ISSUE	DESCRIPTION	DATE	DRAWING PREPARED BY
6	SECTION 75W SUBMISSION 2	26.08.10	BILLBERGIA DESIGN PTY LTD
5	SECTION 75W SUBMISSION 1	04.03.09	TURNER AND ASSOCIATES
4	AMEND SCREENS	16.02.09	TURNER AND ASSOCIATES
3	PRELIMINARY S75W 1 ISSUE	09.01.09	TURNER AND ASSOCIATES
2	ISSUED FOR DRP	13.11.08	TURNER AND ASSOCIATES

PROPOSED DEVELOPMENT
SYDNEY OLYMPIC PARK
STAGE 3 : SITE 1

DRAWING TITLE
WEST ELEVATION

PRINT DATE	PROJECT ID	DRAWING NO.	ISSUE
06.09.10	SOP3.1	DA100	6

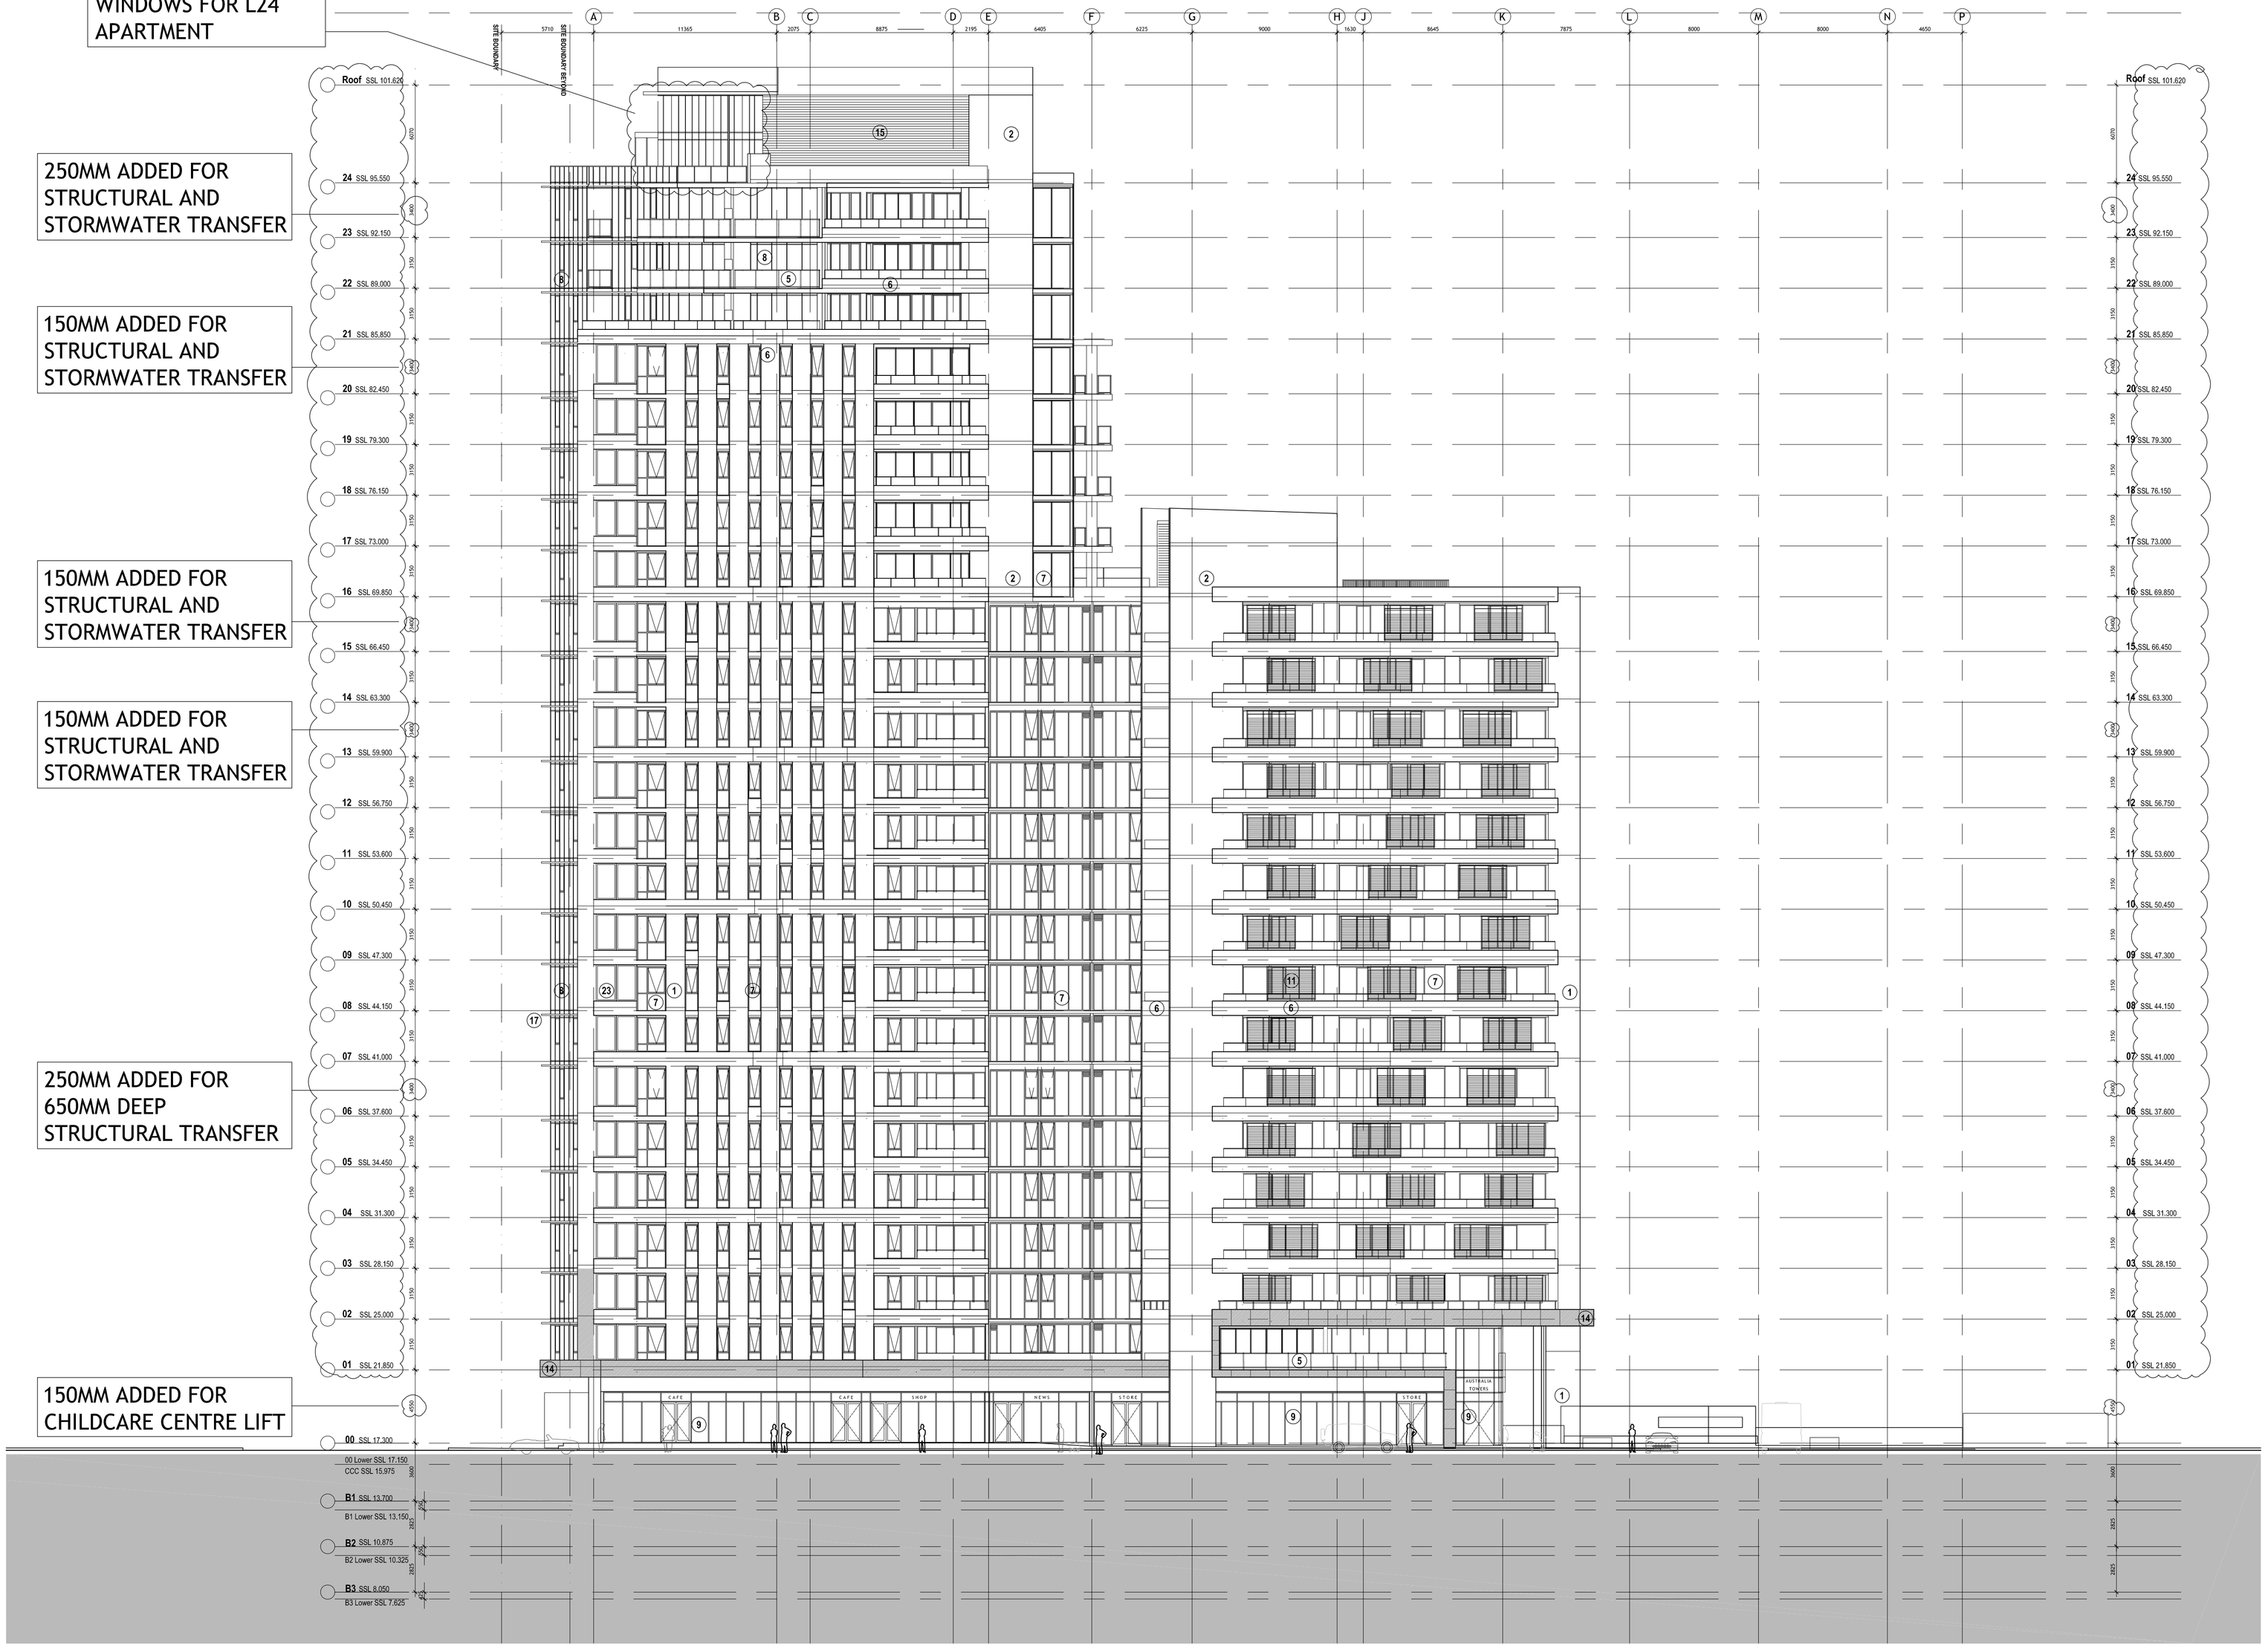
LOUVRES AMENDED TO WINDOWS FOR L24 APARTMENT

250MM ADDED FOR STRUCTURAL AND STORMWATER TRANSFER

150MM ADDED FOR STRUCTURAL AND STORMWATER TRANSFER

150MM ADDED FOR STRUCTURAL AND STORMWATER TRANSFER

150MM ADDED FOR STRUCTURAL AND STORMWATER TRANSFER

250MM ADDED FOR 650MM DEEP STRUCTURAL TRANSFER

150MM ADDED FOR CHILDCARE CENTRE LIFT
